Agenda Item # 3 - HOLDOVER SUB-003675-2026

Resubdivision of the Resubdivision of Revised Bucci
Subdivision

- Subdivision approval to create two (2) legal lots of record from one (1) legal lot of record.

APPLICATION NUMBER 3 DATE July 16, 2026

DETAIL SITE PLAN

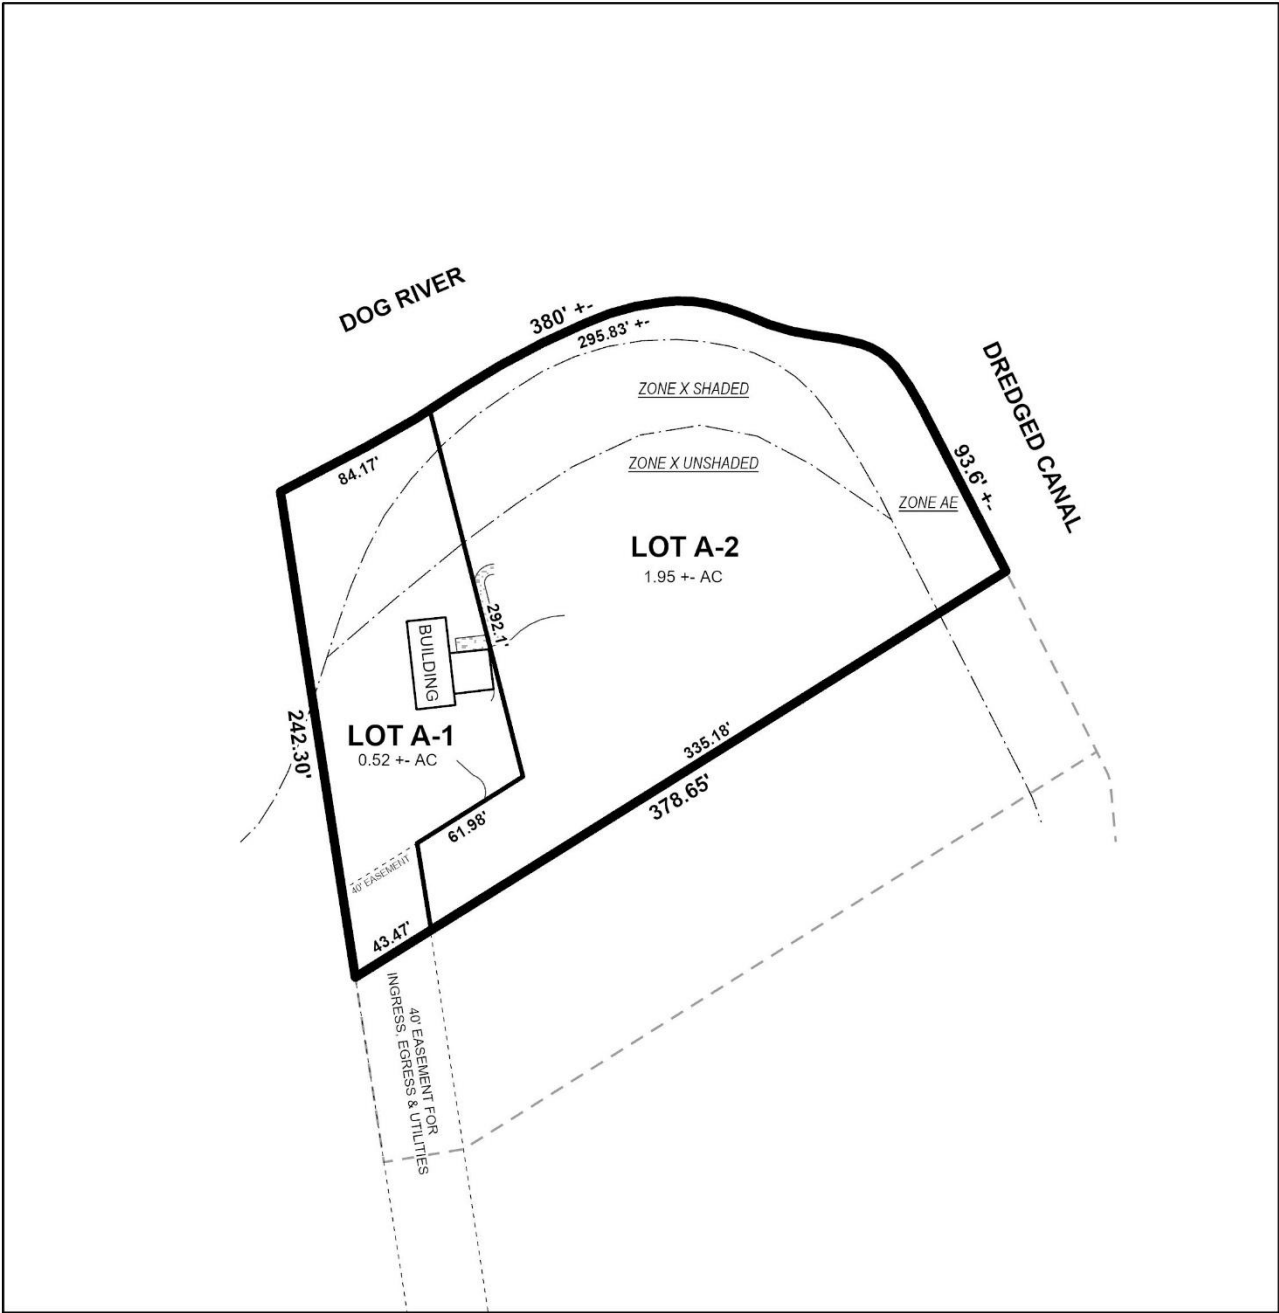
As depicted, it appears that there is an awning on the proposed Lot A-1 that is within the required five-foot (5') side yard setback. As such, either the property line should be relocated so that no existing structures have non-compliant setbacks, or a Variance will be required.

The revised plat does not depict the required 25-foot front yard setbacks for either proposed lot. If approved, the front setback should be depicted on the Final Plat.

It should be noted that the subject site does not have frontage on a public right-of-way, but instead fronts an existing 40-foot easement for ingress, egress, and utilities. As proposed, Lot 2 does not have direct access to this easement. Therefore, if approved, the Final Plat should be revised to extend the western property line of Lot 2 to provide frontage on the existing easement. Additionally, a note should be included on the Final Plat stating that no structures may be constructed within any easement without permission from the easement holder.

The preliminary plat depicts the existing 25-foot minimum building setback line for Lot B of the *Resubdivision of Revised Bucci Subdivision* but does not show setback lines for the proposed lot configuration. If approved, the Final Plat should illustrate the required 25-foot minimum building setback line for both proposed lots, measured from the easement frontage, in accordance with Article 2, Section 64-2-5.E. of the UDC and Section 6.C.8. of the Subdivision Regulations.

1. Either approval of a Setback Variance to allow existing structures to have non-compliant side yard setbacks, or revision of the plat to depict compliant setbacks for all structures;

4. Illustration of the 25-foot minimum building setback line on both lots from the 40-foot private ingress/egress easement;
5. Placement of a note on the Final Plat stating that no structure may be constructed or placed within any easement without permission from the easement holder;
